UNITED STATES
NUCLEAR REGULATORY COMMISSION
REGION III
799 ROOSEVELT ROAD
GLEN ELLYN, ILLINOIS 60137

Attached you will find a copy of the Office of Inspector and Auditor investigation report for Mr. E. Earl Kent dated April 3, 1984. This report is furnished to you for your independent review of the Kent issues. This report may be reproduced and used as necessary to assist you in performing your task. The contents of this report must not be discussed with anyone outside the NRC and only on a need-to-know basis. Please return this copy and all information pertaining to this report when your review is completed to the NRC, Region III. The purpose for this precaution is that this report has not been released by the agency.

Your review of the Kent issues should include those topics pertaining to the Midland nuclear facility as well as the generic issues related to codes, standards, Bechtel's welding procedures and past NRC inspections. At the conclusion of your review you are requested to issue a complete independent report detailing the scope of your review, findings, and conclusions.

DWG: M-632 SHEET 2 REV 15/F1

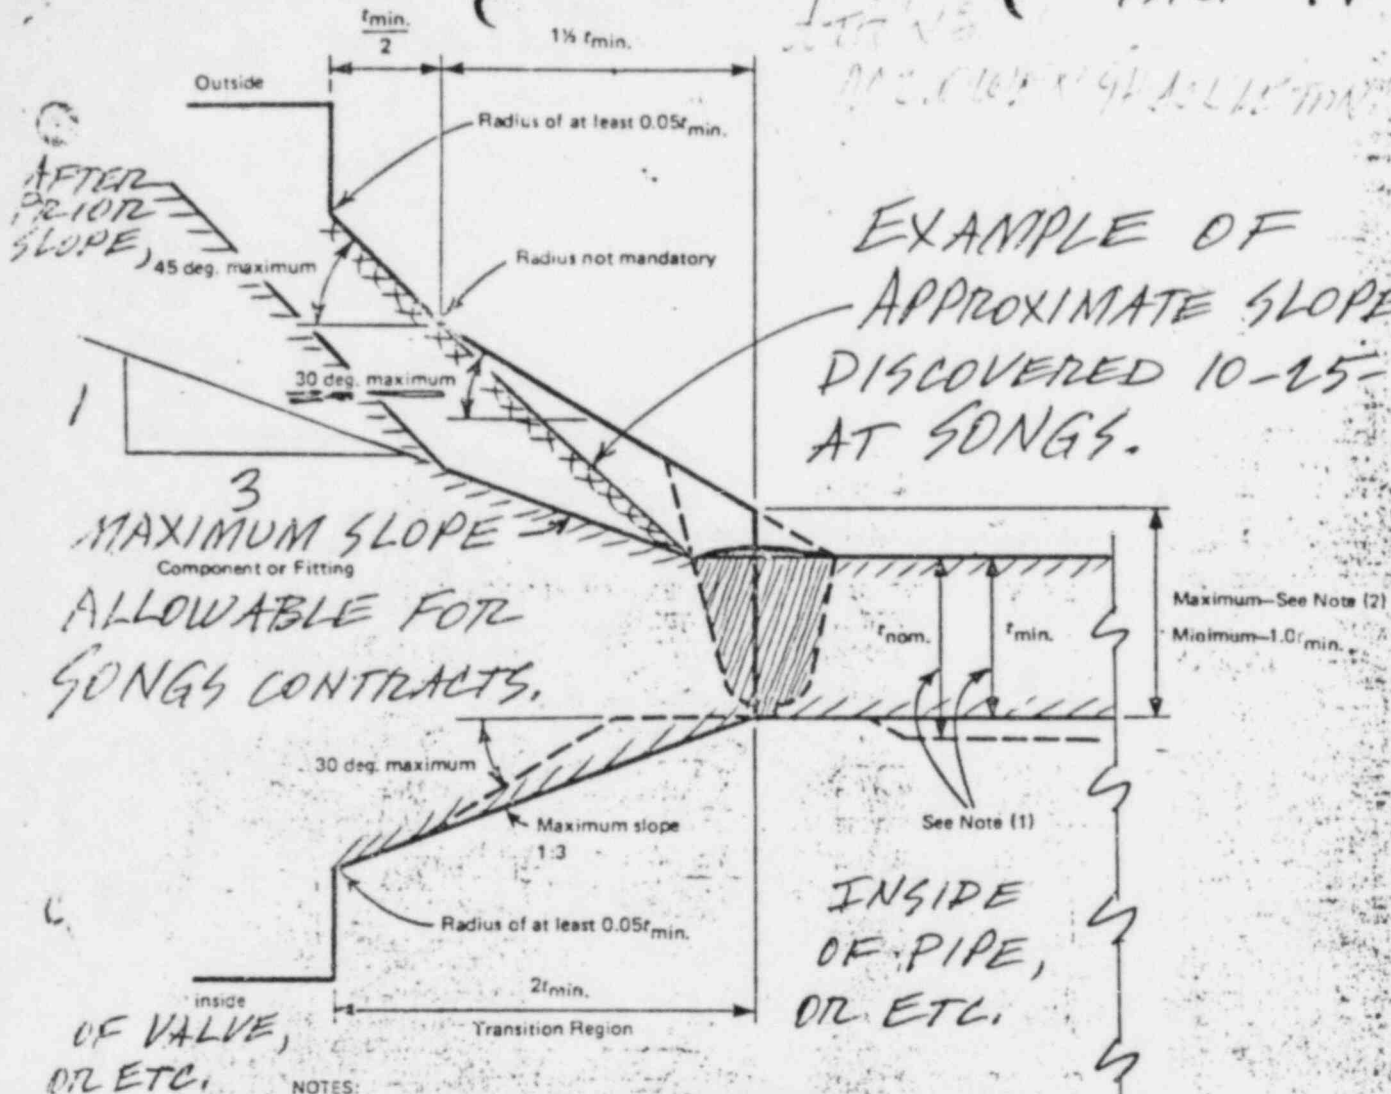
AREA OF CONCERN
+ INDICATING BETWEEN
THE 9 & 12 O'CLOCK
POSITION, EXAMINE
POST.

1. Yes. The results of the Bechtel program (generic issue of undersized welds accepted by QC personnel) were found to agree with the sample of welds inspected during the NRC inspection on 3/3-4/82, which also included three welds specifically identified by E. Kent in his discussion with the NRC. By comparing the dates, it can be seen that Bechtel QC was aware of deficiencies & had initiated corrective action prior to the date E. Kent was terminated. This was also prior to the date of the allegation.
2. No. There is a number of questions that have to be answered with the correct answer to pass the test in which E. Kent could not do.
3. Yes. That is part of the QA/QC job.
4. Yes. Work is reviewed by more than one person even if it is accepted the first time. It is not always accepted by the second person.

SIGNATURE S. HOLLAN DATE 9/10/82 CHECKED D YEH DATE 9-16-82
PROJECT SONKS 2 & 3 JOB NO. 10079-003
SUBJECT PERSONNEL HATCH HINGE SUPPORT SHEET 2 OF 6 SHEETS

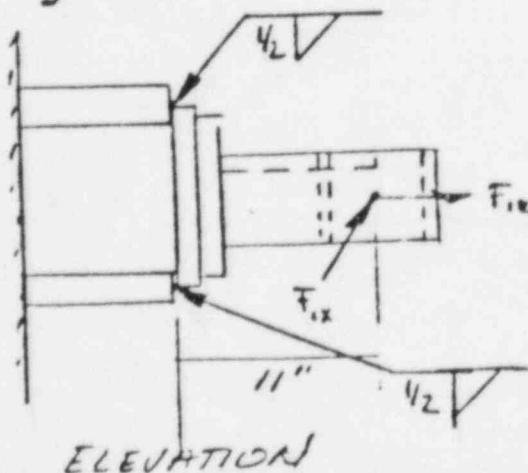
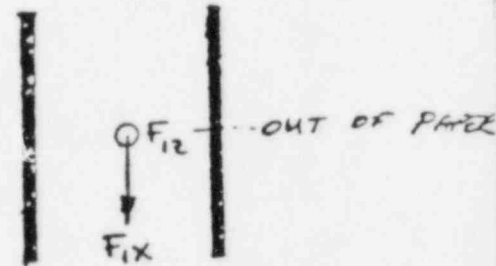
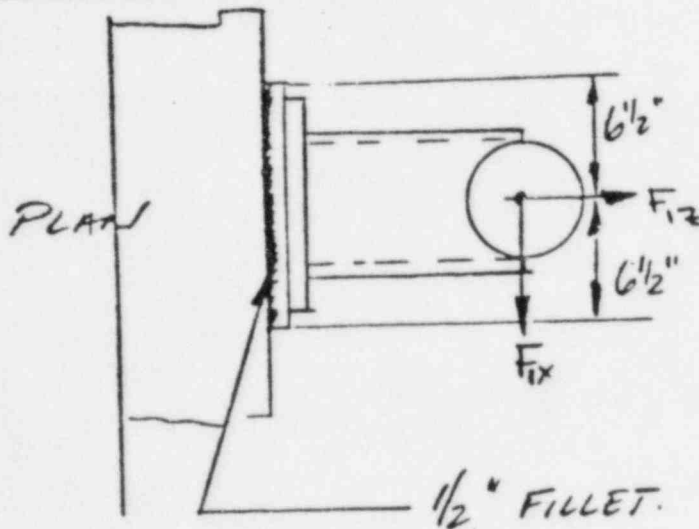
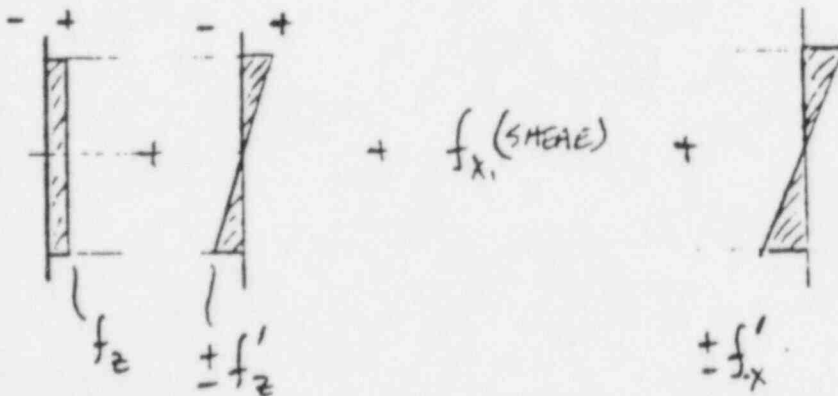
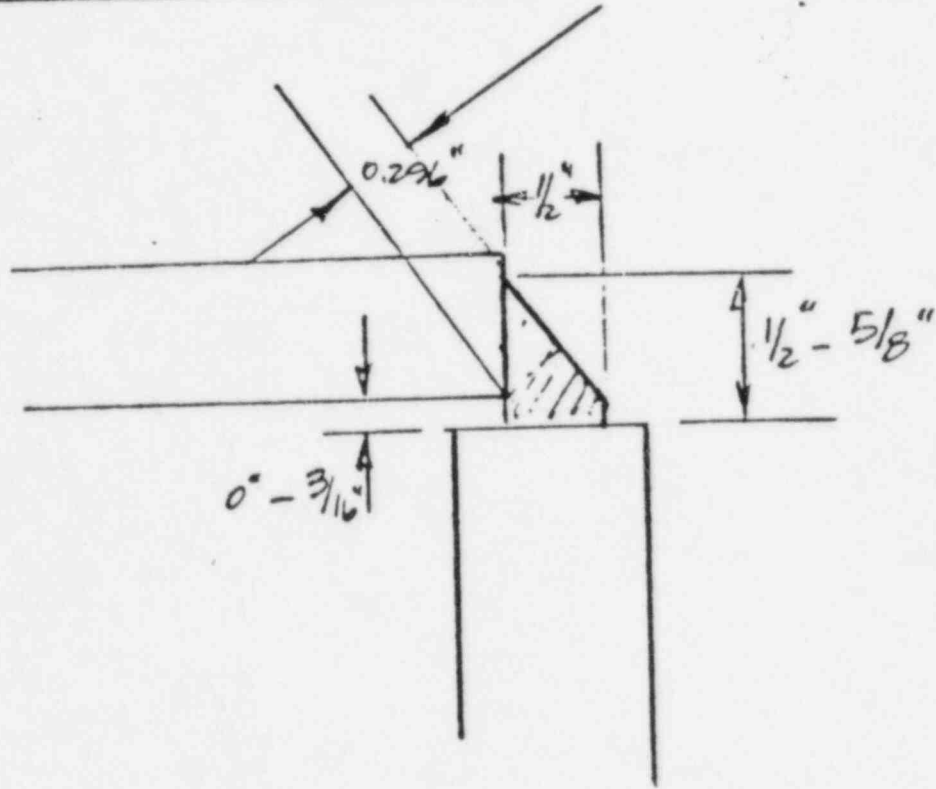
DUE TO QCE INSPECTION, A WELD ON THE UPPER HINGE OF THE PERSONNEL HATCH WAS FOUND TO HAVE AN EFFECTIVE THROAT OF 0.296" (BY FIELD INSPECTION) FOR A 3" LENGTH AT THE END OF THE WELD. SEE DIAGRAM ON PAGE 5.

CONSIDER 3" OF WELD WITH EFFECTIVE THROAT
OF 0.296 IN TO BE INEFFECTIVE AS IT IS
LESS THAN AISC 7TH EDITION REQUIRED MINIMUM
FOR 2 1/2" ϕ \therefore NEGLECT

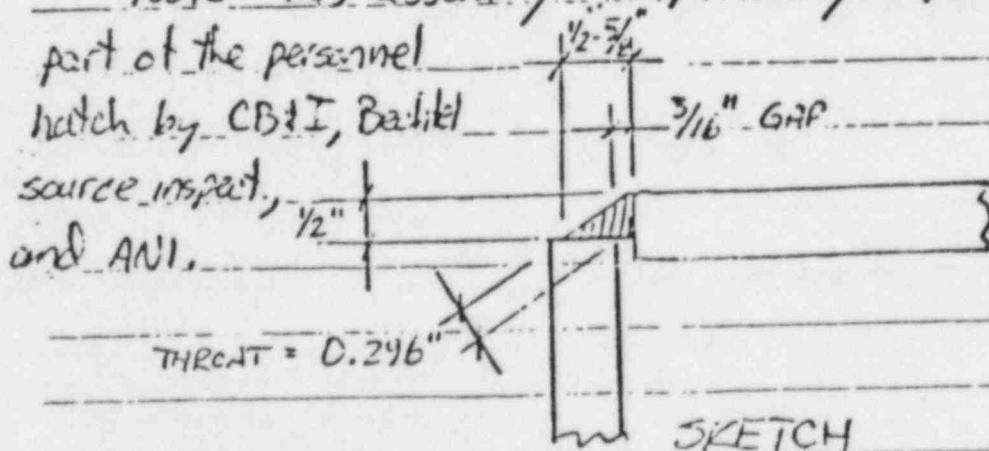
NOTES I described to Ralph Kane and Jack Nazarian a $\frac{1}{2}$ " fillet weld which is part of the hinge support for the inner door of the personnel lock in U-2 Containment. This weld was examined by a welding GCE and found to have a throat dimension of 0.296 in. over a three in. length. The nominal throat dimension for a $\frac{1}{2}$ " fillet weld should be 0.350 in. This condition is attributed to a gap between the two welded plates of approx $\frac{3}{16}$ ". See sketch below.

Ralph and Jack investigated this condition and determined that the reduced throat over a small length of the weld was well within the tolerances of design accuracy. They both felt that the weld can be left as is with no detrimental affect on the structure.
